ELLIS & WATTS INTERNATIONAL, INC  
4400 GLEN WILLOW LAKE LANE BATAVIA, OH 45103  
(513) 752-9000

10/10/01 SB-009

## **SERVICE BULLETIN**

The following issues pertain to LC20M, LC20M/RAC, LC20M/WC, LC20MT, LC20MT/O, LC18MT/WC, model chillers:

Crack  
location

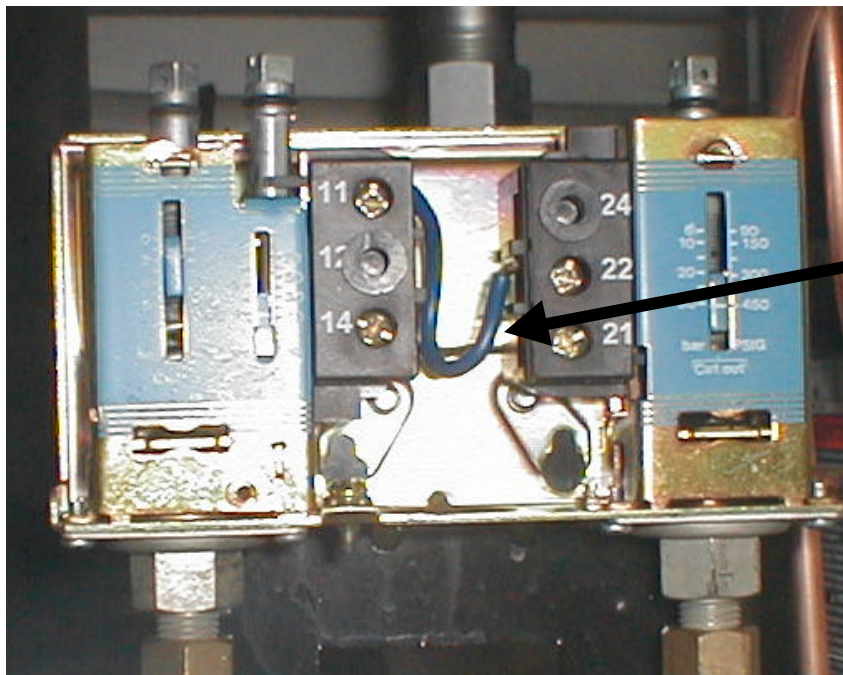
2. It has been brought to our attention that there have been occurrences of cracked Quick Disconnect (QD) fittings (see attached photo). This problem can occur on units with brass QD fittings. We are requesting that all service providers visit each site and inspect all QD fittings for cracks. Please contact E & W Service department with your findings (866-863-7784).
